The 55 details drawn differently in CAD and Revit

Checked against the new drafters' file, 26 October.

55 of the 190 CAD typical details have a Revit version in your templates that is drawn differently. Each page: your CAD detail on the left, the Revit version on the right, what differs, and one answer: CAD is right, Revit is newer (we update CAD from it), or both wrong.

CAD: KOR-S302-DET 07 - TYPICAL WALL AND ZONE VERT REINFORCING DETAIL THICKNESS CHANGES

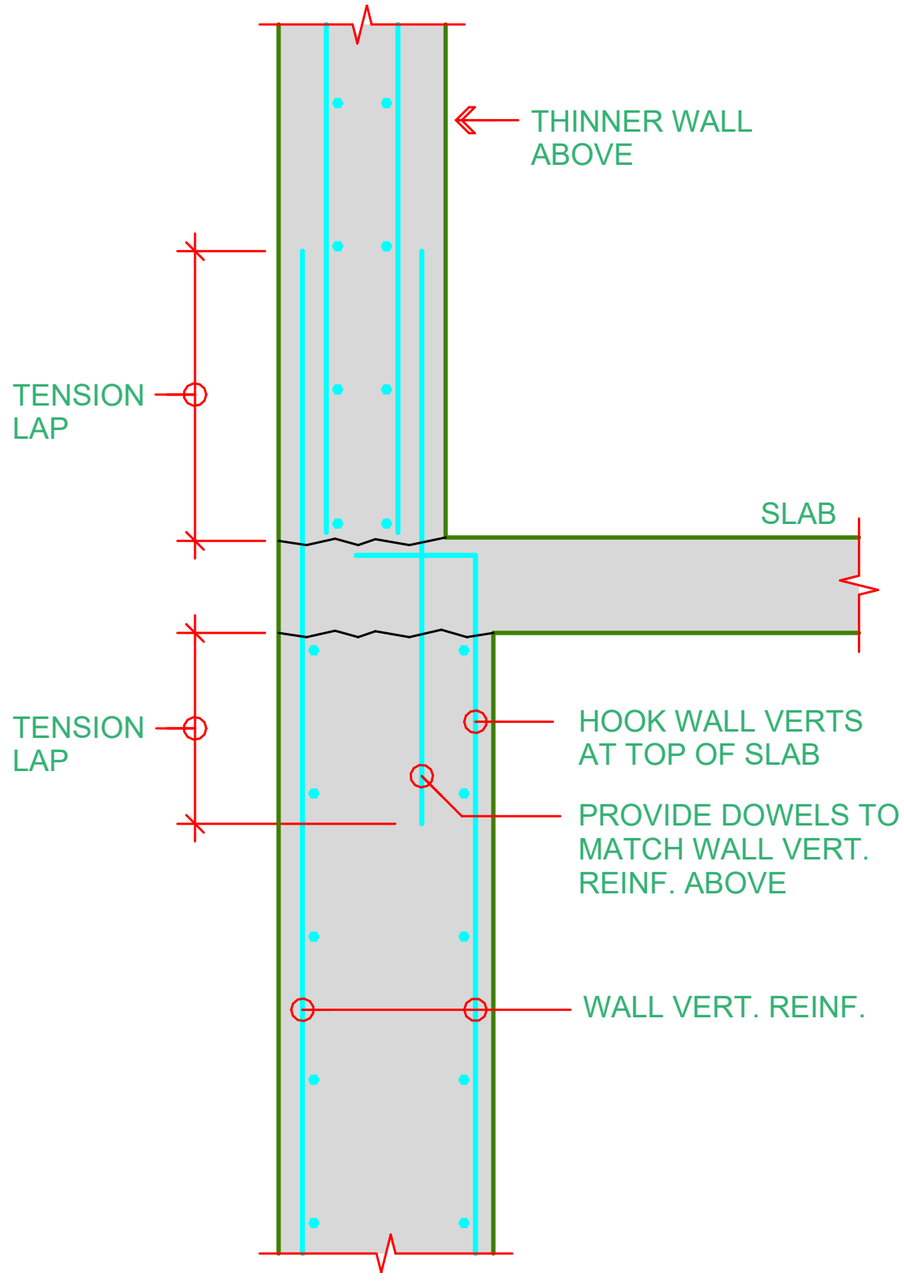
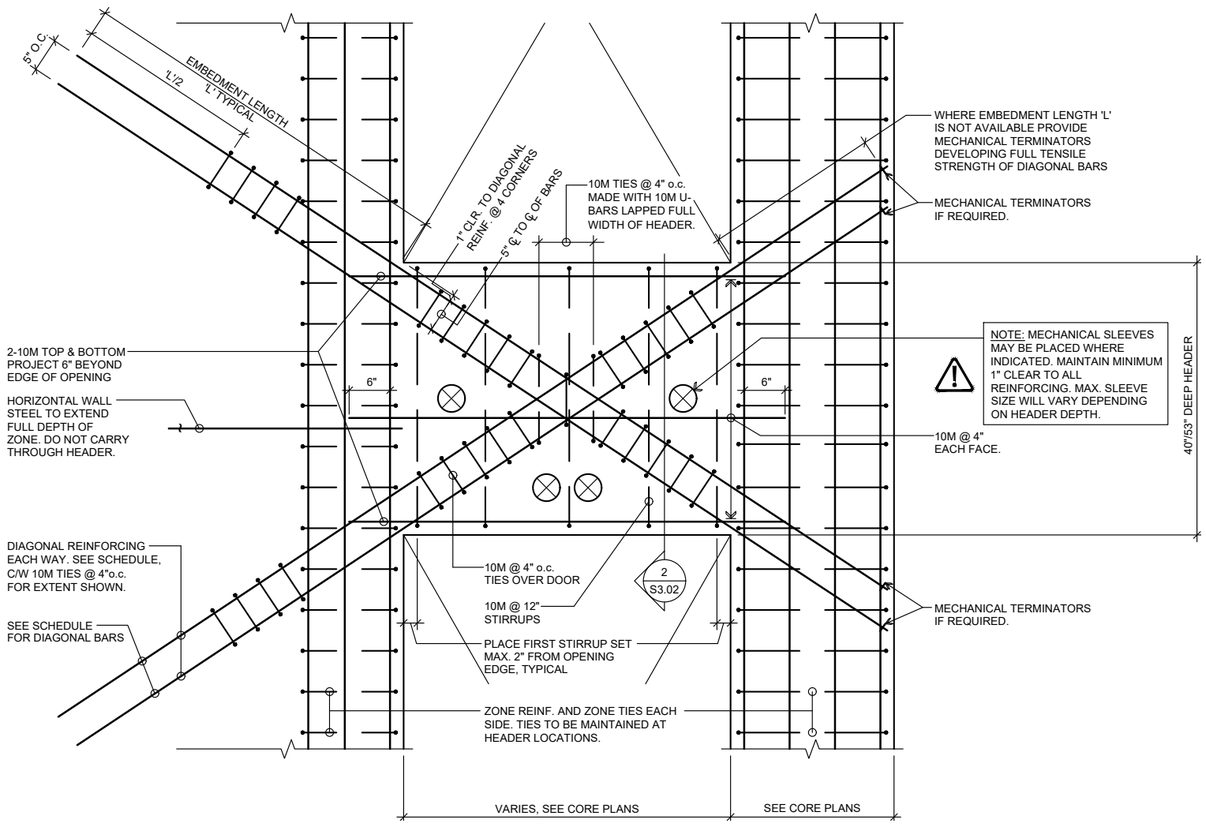
What differs: CAD is the THICKER-wall-above case with hooked dowels to match the wall verts and one tension lap; '1E3.05_6_TYPICAL WALL AND ZONE VERT REINFORCING DETAIL WHERE WALL THICKNESS CHANGES'/'D3.05_6_TYPICAL WALL AND ZONE VERT. REINFORCING DETAIL WHERE WALL THICKNESS CHANGES' are the thinner-wall-above case.

53 of 55 CAD: KOR-S302-DET 12 - TYPICAL DIAGONALLY REINFORCED HEADER DETAIL

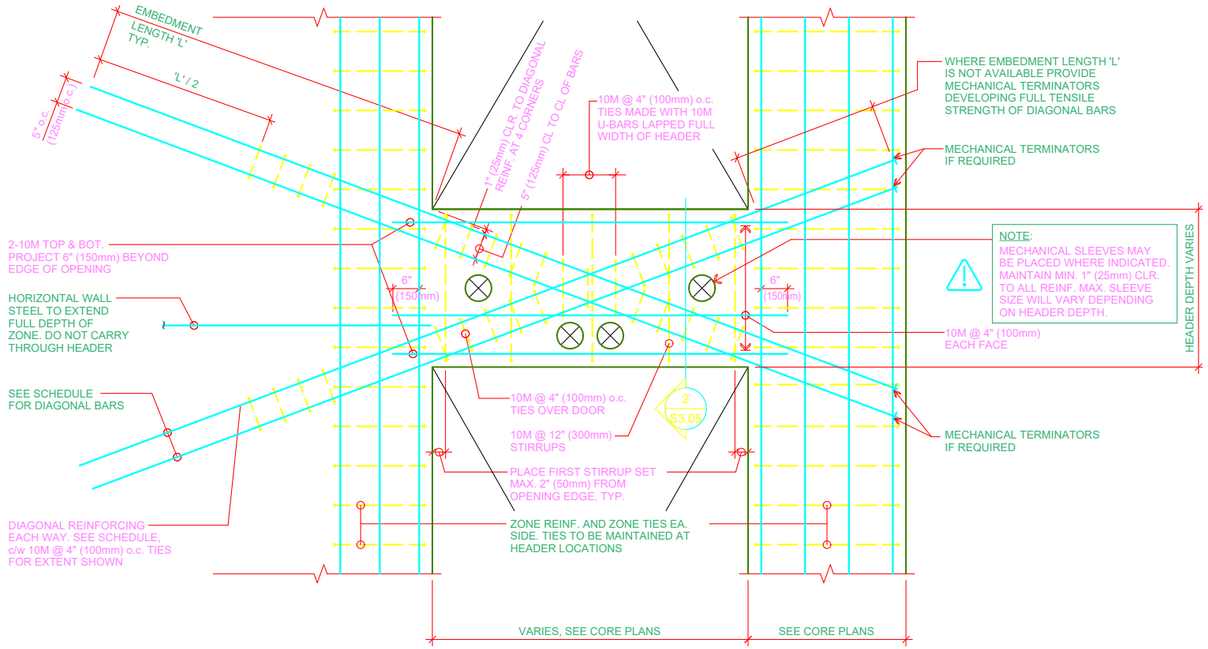
What differs: CAD is a larger, project-specific 40in/53in deep header elevation with mechanical terminators and sleeve notes and no embedment tables; '1E3.05_1_TYPICAL DIAGONALLY REINFORCED HEADER DETAIL' is the generic version with tables.

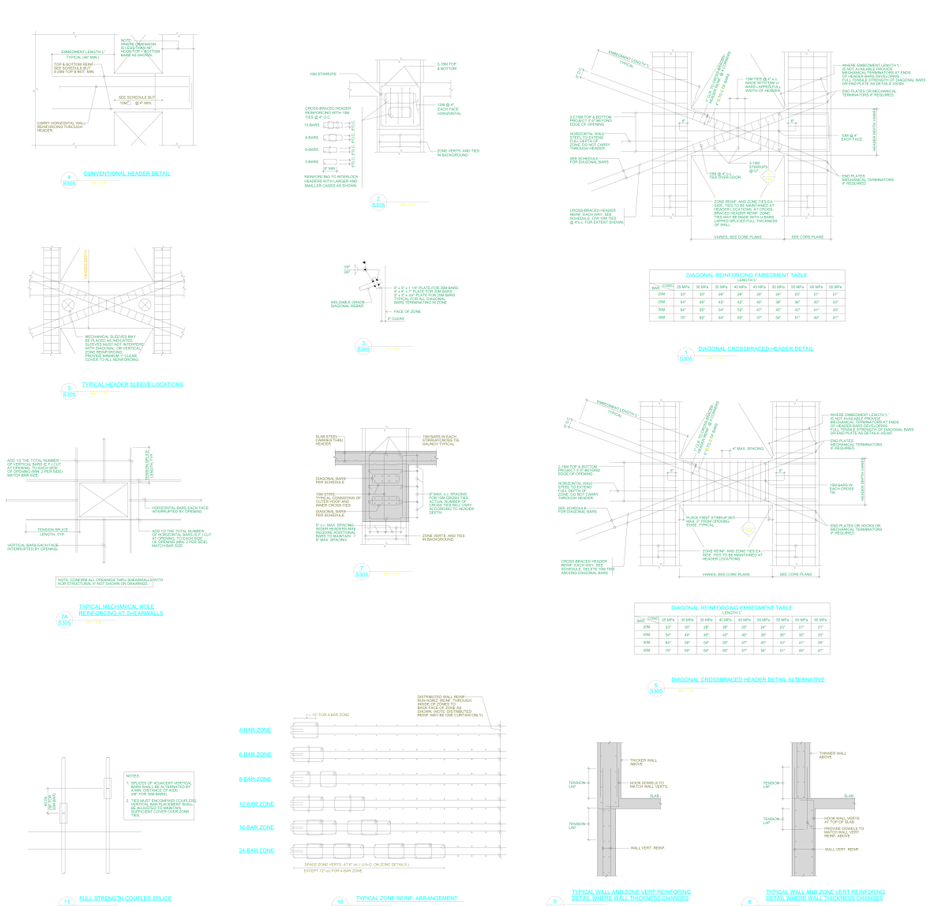
What differs: Same notes as 'G002 - 31.0 SHEAR WALL AND ZONE REINF' but CAD has 11 items, including the clouded 50% staggered zone splice note that 'G002 - 31.0 SHEAR WALL AND ZONE REINF' lacks.

Your template: TYPICAL SHEARWALL DETAILS (Concrete Tower R24; on no sheet)

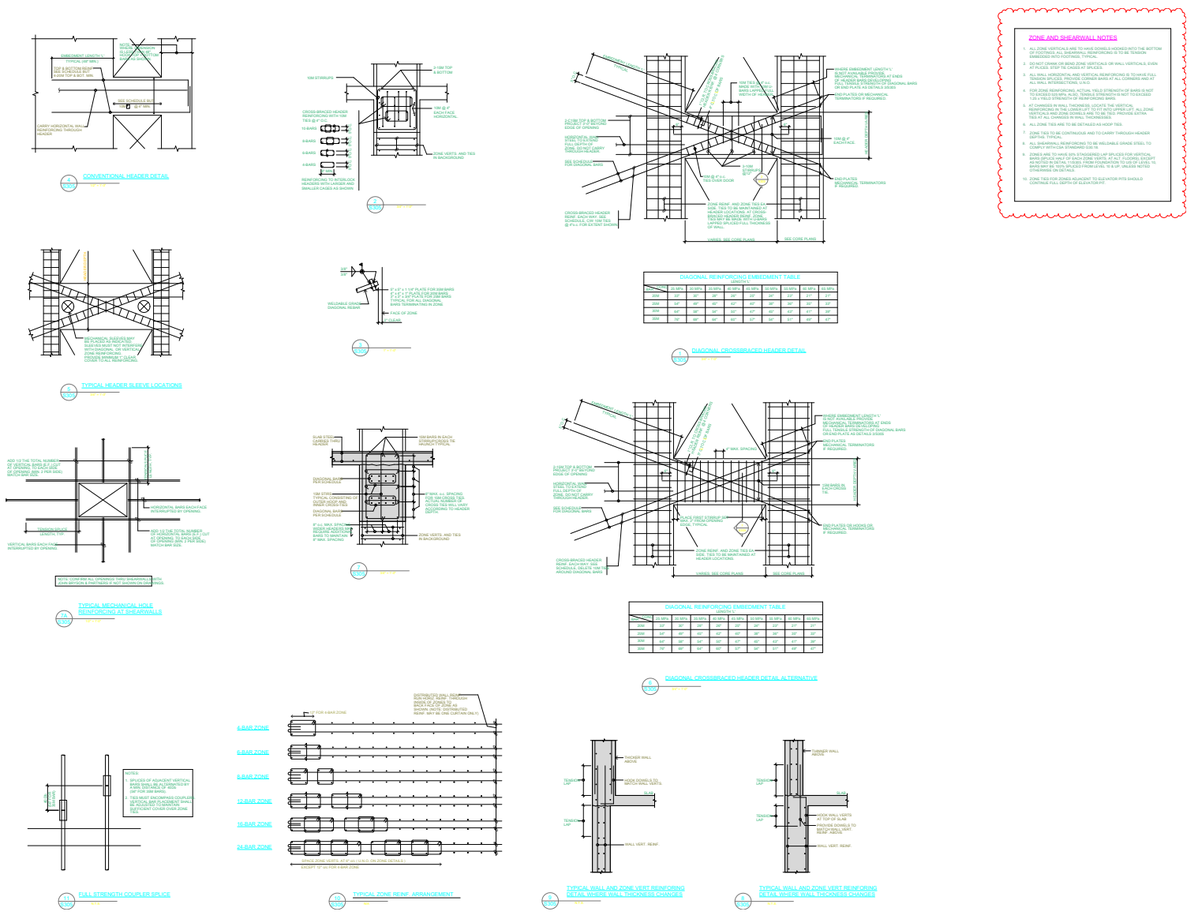
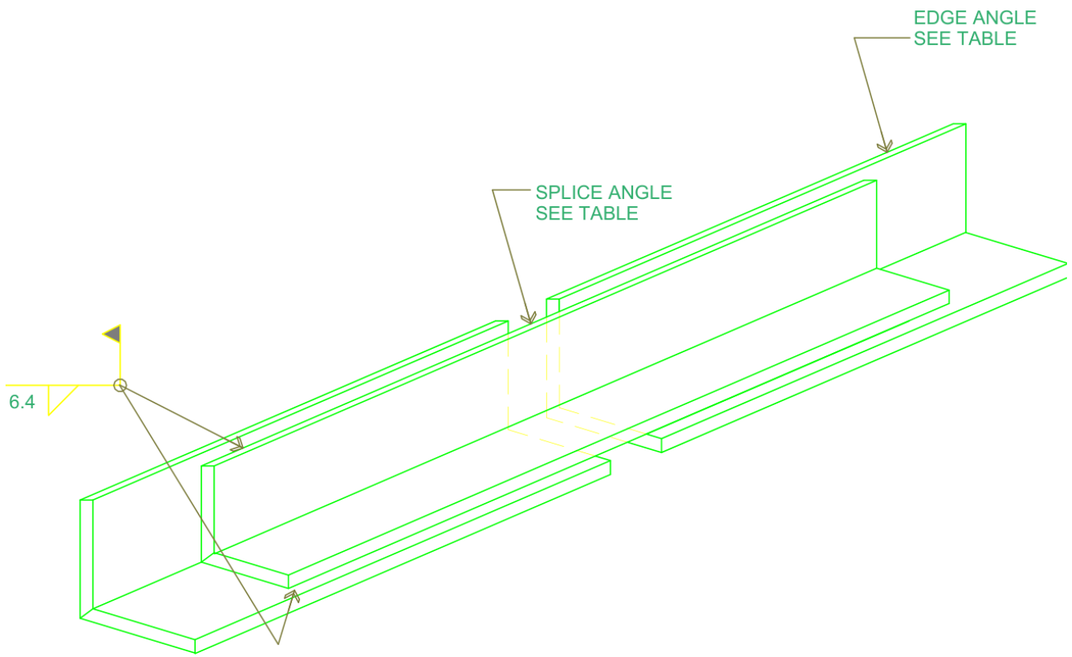
What differs: 9 of 9 grid pieces identical except note 7A: candidate says "JOHN BRYSON & PARTNERS", old says "KOR STRUCTURAL"

57 of 61 OLD CATALOGUE: KOR-D-00425 - EDGE ANGLE SPLICE DETAIL

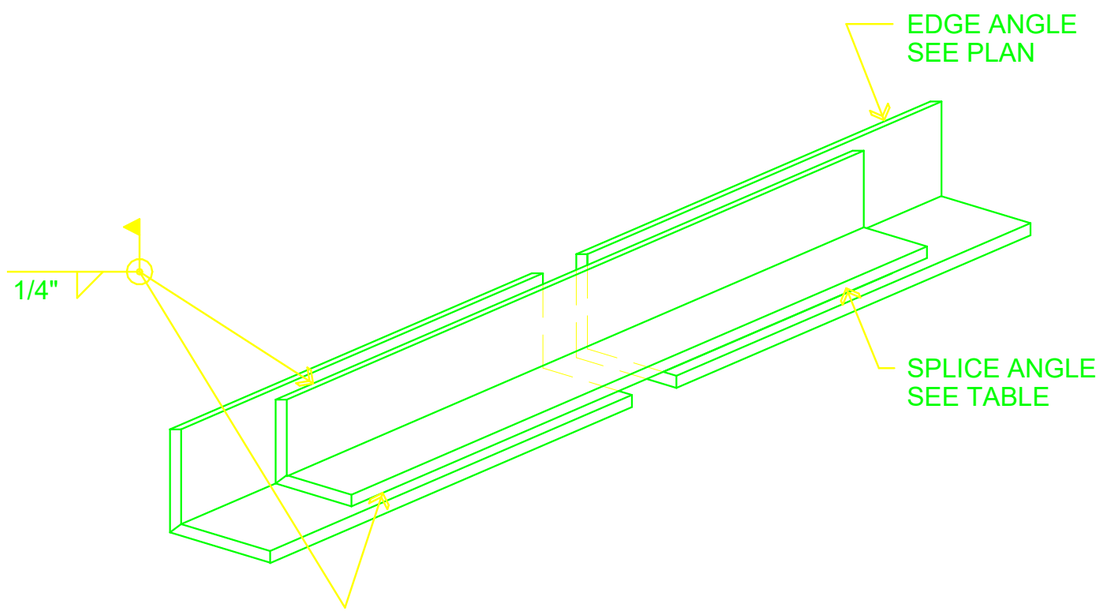
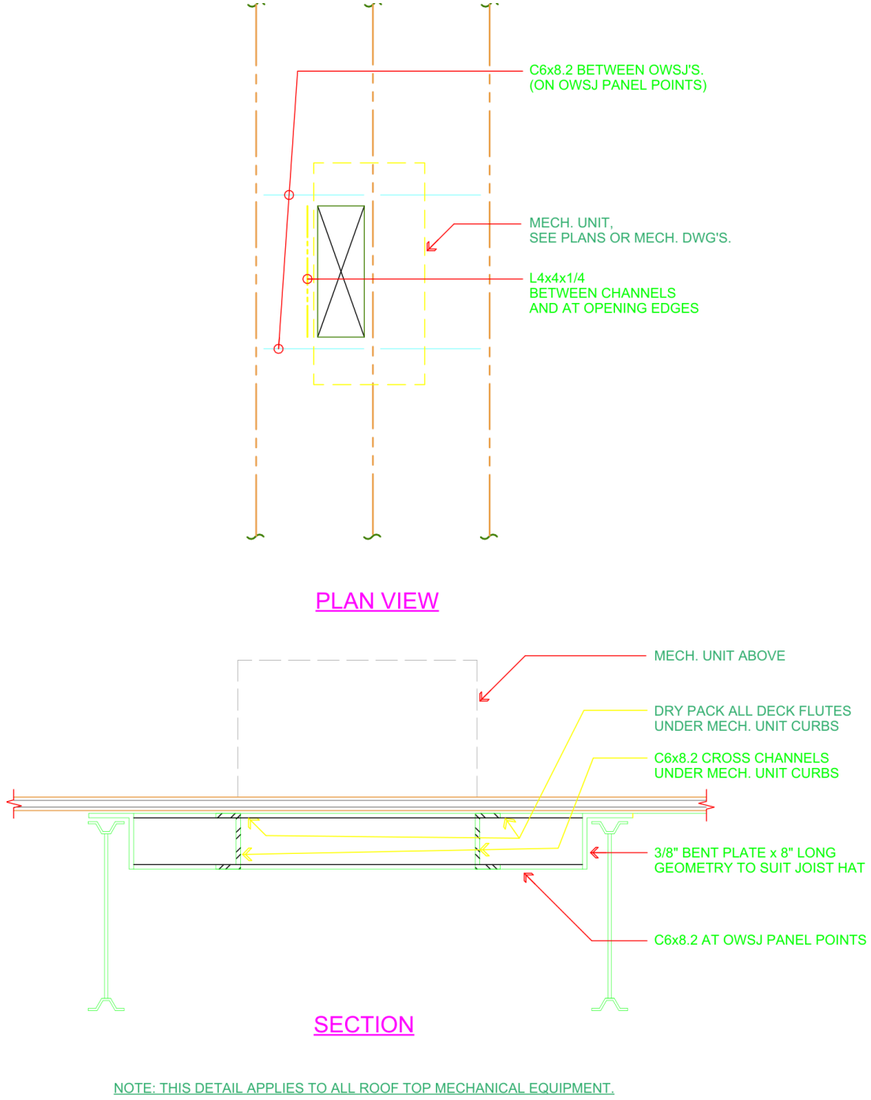
What differs: same isometric; old metric 4-row table (L102x102x6.4..L152x102x13, 6.4 weld); candidate imperial 5-row (L3x3x1/4..L5x5x1/4, 1/4"), blank headers

Your template: TYP. MECH. UNIT SUPPORT (ROOF OPENINGS) (Steel R24; on no sheet)

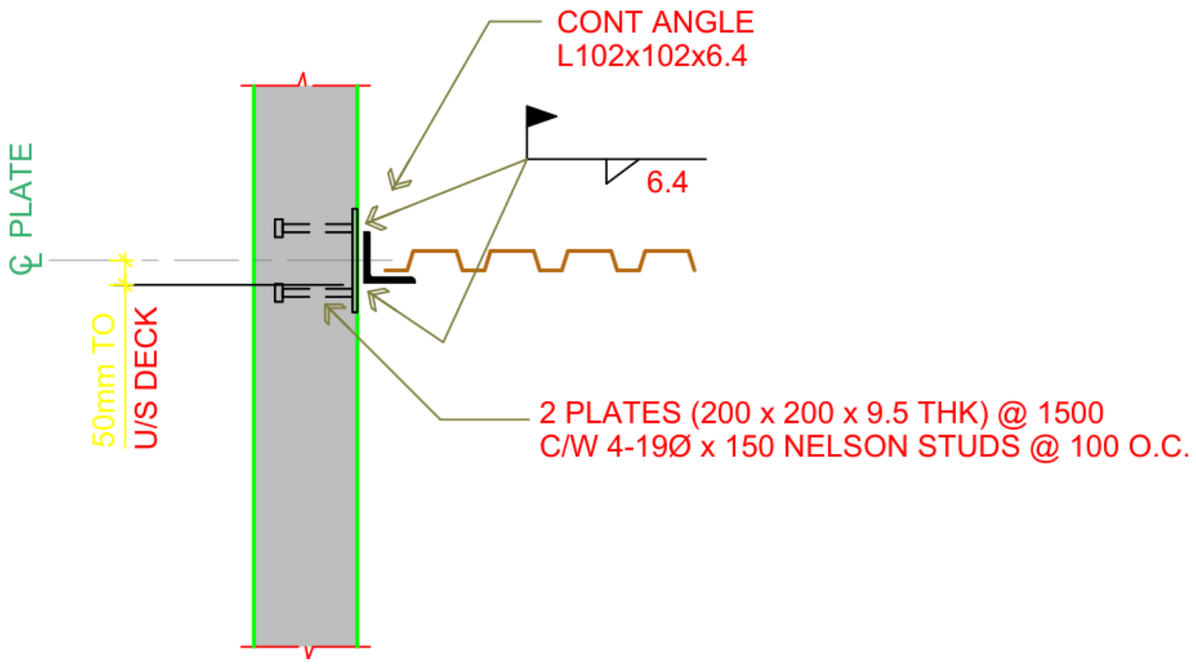
What differs: old plan+section appear inside; candidate adds 750-2000 lb / <750 lb framing cases box and notes; L4x4 label reworded

Your template: TYP. CONNECTION FOR STEEL DECK TO CONC. WALL (Steel R24; on no sheet)

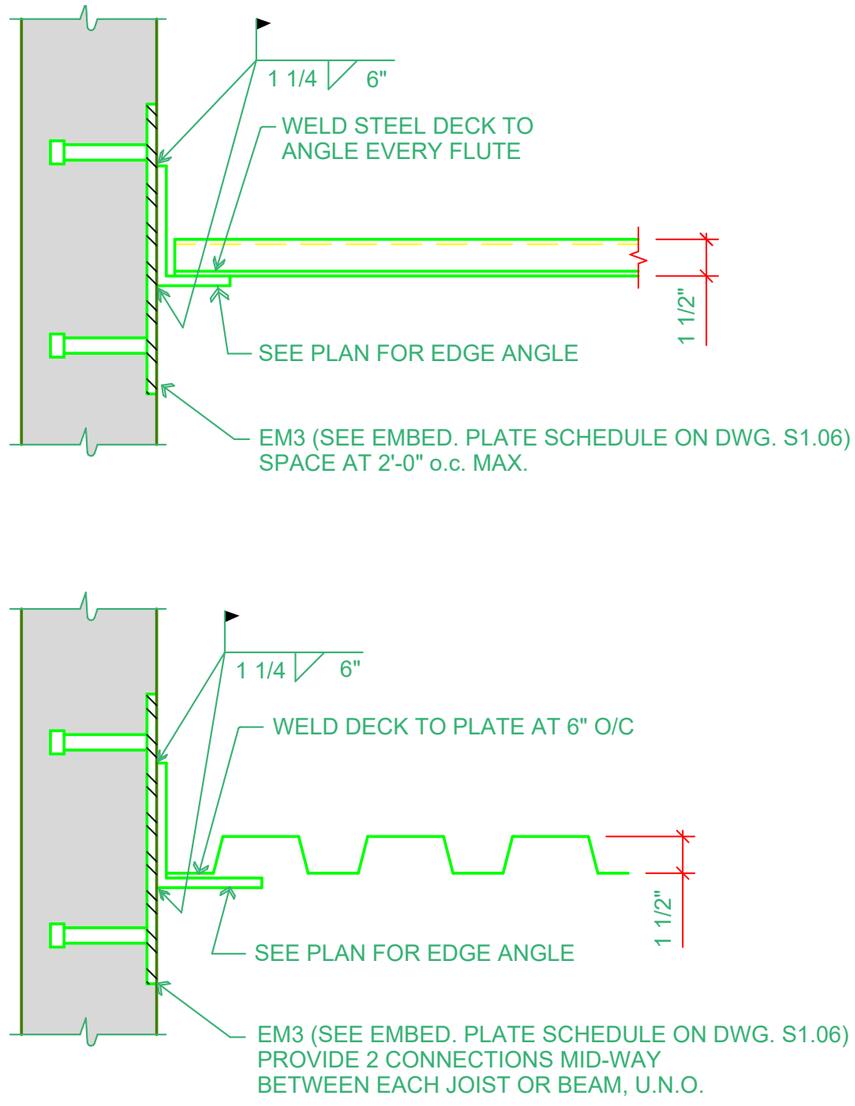
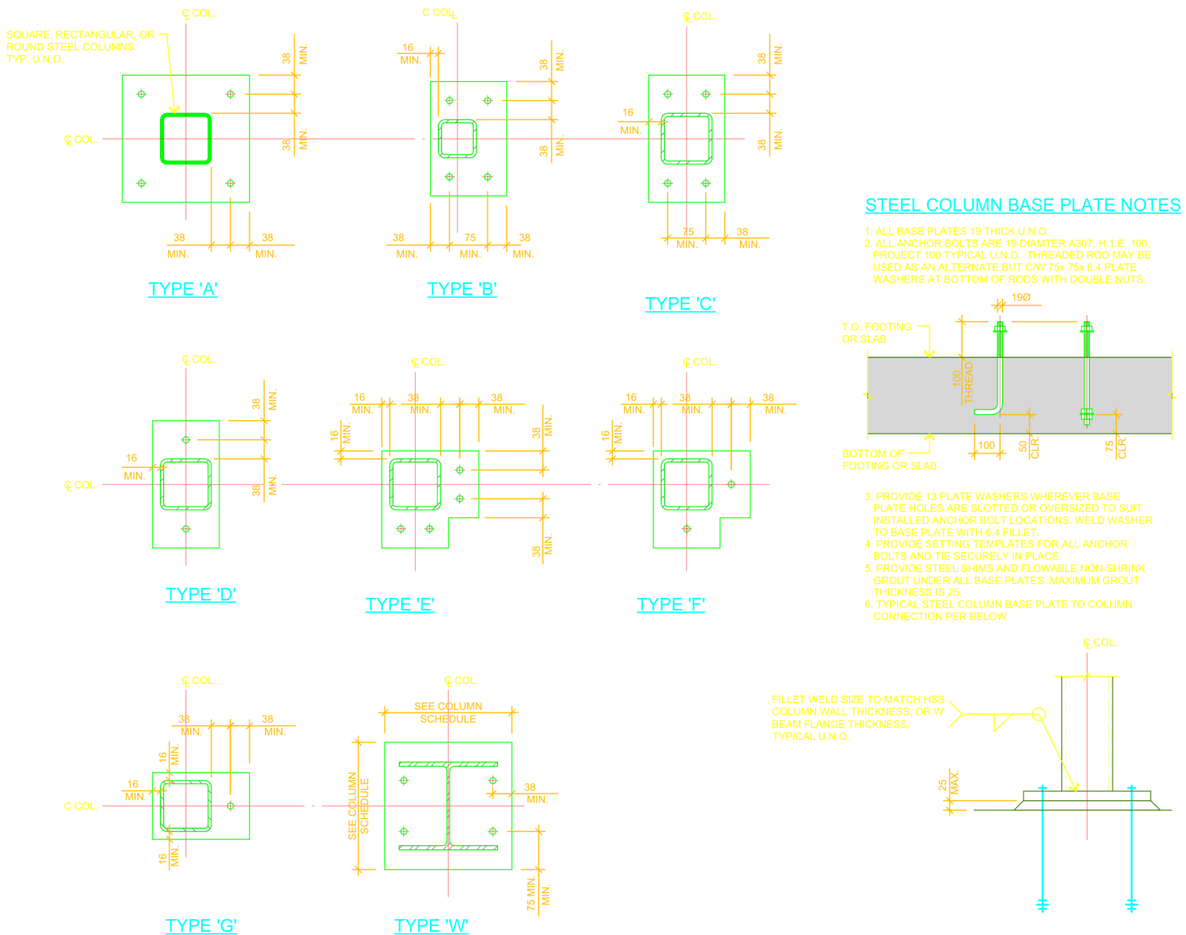
What differs: old: one case, L102x102x6.4 on 200x200x9.5 plates w/ 4-19 studs @1500, 6.4 weld; candidate: two deck cases, EM3 schedule plates, 1-1/4@6 stitch, imperial
